Date: June 3, 2015
To: All Prime Bidders
RE: Eugene School District 4j
Edgewood Elementary School – Cafeteria HVAC 2015
C.I.P. No. 420.248.032

ADDENDUM #1:

EUGENE SCHOOL DISTRICT 4J:
EDGEWOOD ELEMENTARY SCHOOL
CAFETERIA HVAC 2015

AD = 1

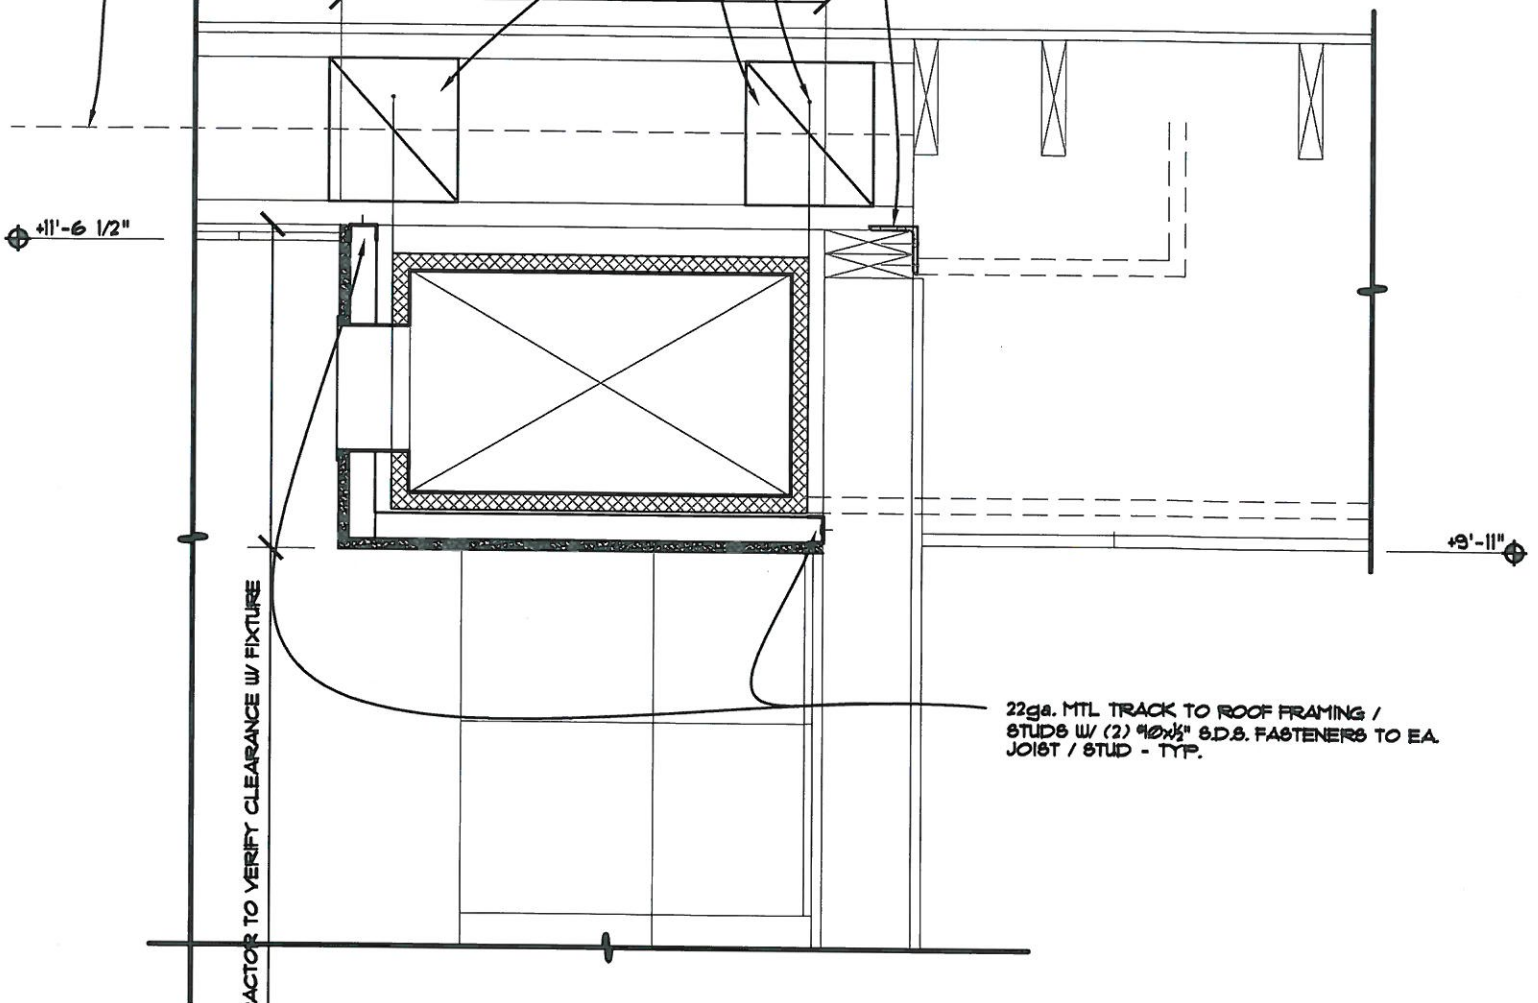
- Item #6: See the attached detail AD-1 indicating duct supports, framing attachments and steel header(s).
- Item #7: See the attached detail AD-2 showing the vertical joint connection between the existing wall finishes and the new wall finishes.

FASTEN DUCT HANGERS ABOVE THE NEUTRAL AXIS @ 4'-0" O.C. MAX. CONTRACTOR TO SUBMIT DUCT HANGING HARDWARE FOR ENGINEER'S REVIEW - TYP.

PROVIDE FULL-HT. WEB STIFFENER @ DUCT HANGERS - TYP.

L3x3x1/4" TO SPAN OVER STUD(S) REMOVED FOR DUCT ACCESS - FASTEN TO DBL. TOP. PL. W/(4) 1/4"x3" S.D.S. SCREWS EA. END - TYP.
